VOLKSWAGEN
GROUP OF AMERICA

Subject: FHWA Advance Notice of Proposed Amendments: *National Standards for Traffic Control Devices; the Manual on Uniform Traffic Control Devices for Streets and Highways; Revision*, FHWA Docket No. 2020-0001, 85 Fed. Reg. 80898 (December 14, 2020)

Appendix: VWGoA Automated Vehicle Enhancement Suggestions for the MUTCD

Figure 2: non dedicated scenarios added with dashed lane markings for additional guidance

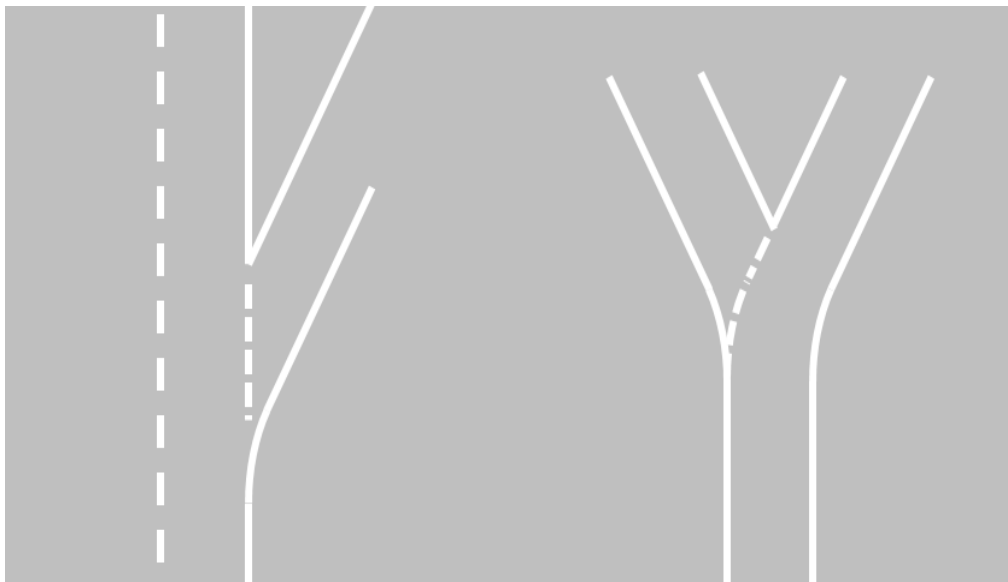
Non-dedicated exit lanes leave areas with uncertainty where there is no sufficient guidance available. These areas should be avoided by adding specific dashed lines along an exit scenario to drag traffic towards the main suggested path.

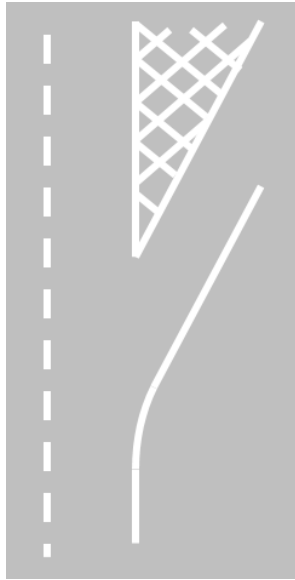
Short dashed lane markings should be standardized in terms of

- Marking length (> 3ft)
- Marking width (> 10in)
- Distance between individual markings (> 5ft)

No other markings and/or other obstacles should be placed between the individual marks of a high frequency lane.
